**DEFENSE NUCLEAR FACILITIES
SAFETY BOARD**

Staff Issue Report

SUBJECT: Plugging of Process Lines, Pretreatment Facility, Waste Treatment and Immobilization Plant, Hanford Site

Figure A-1. Flow Regimes for Centrifugal Pumps HLP-PMP-00017A/B

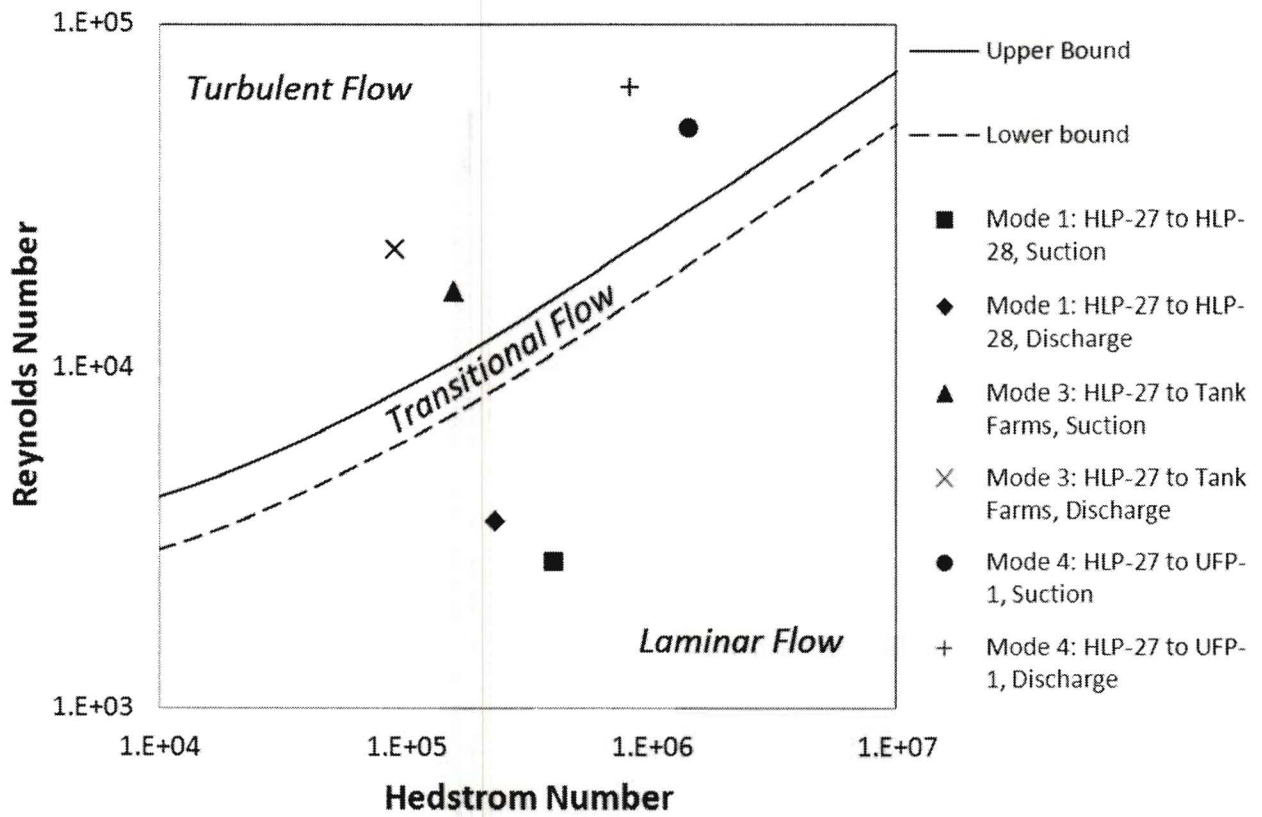
Figures A-1 through A-3 below depict flow regimes for centrifugal pumps at the Pretreatment Facility (PTF) for transferring non-Newtonian slurries (Prado, 2011a, 2011b; Bauer, 2011). These figures show that the current design strategy for non-Newtonian pipelines at PTF will produce laminar or transitional flow in several non-Newtonian process lines, which may lead to pipeline plugging.

Figure B-1. SAR Number for Simulated WTP Process Streams

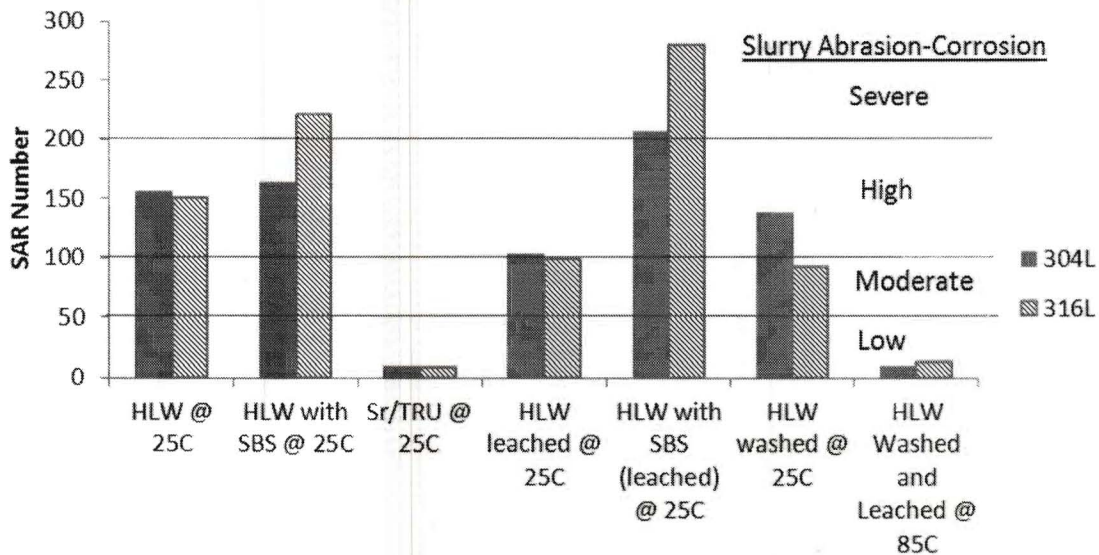
Duignan (2002) produced seven WTP waste stream simulants and performed a standard abrasivity test per ASTM G75-01, *Standard Test Method for Determination of Slurry Abrasivity (Miller Number) and Slurry Abrasion Response of Materials (SAR Number)* (American Society for Testing and Materials, 2001), to determine a Slurry Abrasion Response (SAR) number for two types of stainless steel used by the WTP project, 304L and 316L. The ASTM G75 method uses a Miller number machine to determine the severity of abrasion-corrosion of the slurry on the wear materials by measuring the rate of mass loss from the material specimen and converting these data to a SAR number. During a test, a stainless steel wear block is attached to a reciprocating arm that slides the block at a controlled rate across a trough filled with slurry. Mass loss of the wear block occurs as the bottom of the block abrades from the sliding action of the block, slurry, and bottom of the trough. The ASTM method specifies that the bottom of the trough is made of a standard lap material, neoprene. The block is machined to dimensions specified by the standard and loaded with a total downward force of 22.24 N (5 lb). SAR number results from the seven simulated WTP slurries are shown in Figure B-1 along with a rating scale that shows regions of low to severe abrasion-corrosion. The results indicate that process chemistry, e.g., the addition of the submerged bed scrubber (SBS) solution, plays an important role in abrasion-corrosion of WTP process streams.

BNI's wear calculations assume that the stainless steel piping will experience little erosion at low flow velocities due to the small size and amount of hard waste particles. ASTM G75-07 (American Society for Testing and Materials, 2007) states:

During a May 8, 2012, conference call, BNI stated that they do not consider the Duignan (2002) data to be significant because of the simulants used, i.e., approximately 7 wt% of the simulant solid consisted of tungsten oxide. BNI indicated that tungsten oxide is a very hard material that is not representative of the Hanford wastes. To the contrary, the simulant was developed by Pacific Northwest National Laboratory as documented in a report by Elmore (2000). Elmore provides the basis for selecting tungsten oxide and states:
